Traffic Impact Assessment

Additional Information Required for Planning Application PLN-21-0195- Multiple Dwellings x 21 at 47 Marlborough Street, Longford

**RE: Planning Application, 47 Marlborough Street and Marlborough Street Road Reserve,
Longford PLN-21-0195**

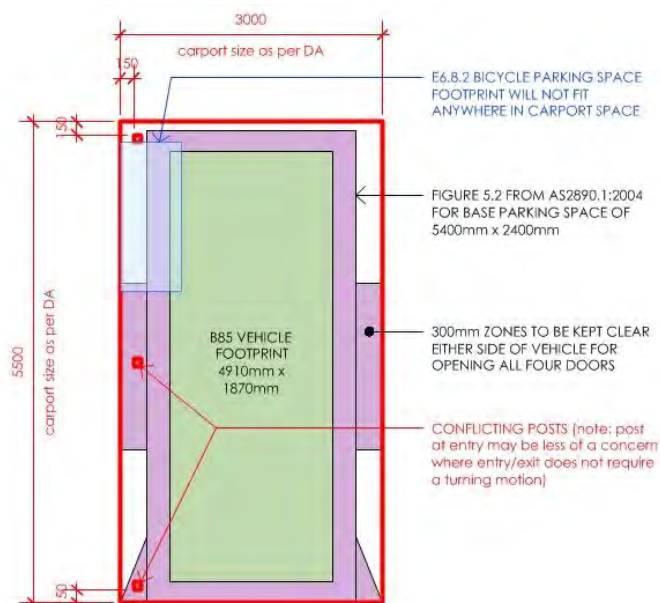
Figure 5.2 of the Standard identifies the vehicle envelope required for parking spaces. The proposed carport design is typical for all units with a footprint of 5500mm x 3000mm and three posts of 90x90mm to the external side supporting the roof located approximately 150mm from the edges of the slab. As such, two of the posts fall into zones Figure 5.2 requires to be kept free of obstructions as demonstrated in the diagram below.

On this basis, the proposal does not appear to comply with AS2890.1:2004 and given the areas of non-compliance impact convenience and safety, cannot be said to satisfy the relevant performance criteria.

The size of the carports proposed are 5.5m x 3.0m which exceed the requirements of Table E6.3. This table does not detail whether car parking spaces are to be free of posts or supports, and should this be an issue, I am sure the proponents could provide amended plans, as per a condition on an approval prior to the issue of a building permit for such.
